HL 1-26 & DDR 1-26

March 12, 2026, Historic Landmarks Committee Meeting

HL 1-26

DDR 1-26

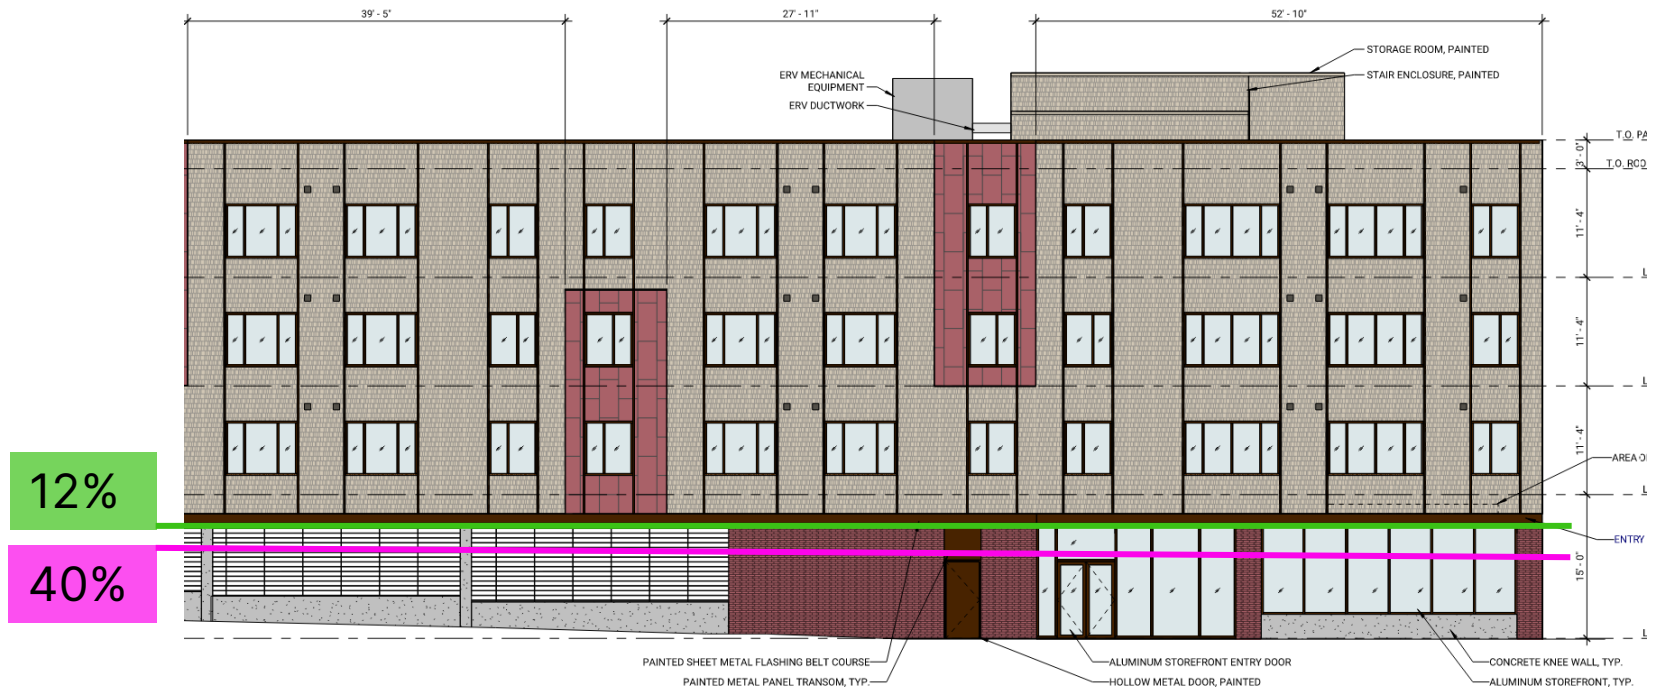
- Criteria 3c and 8

- Criterion 1

**ADDITIONAL INFORMATION REQUESTED FROM
APPLICANT**
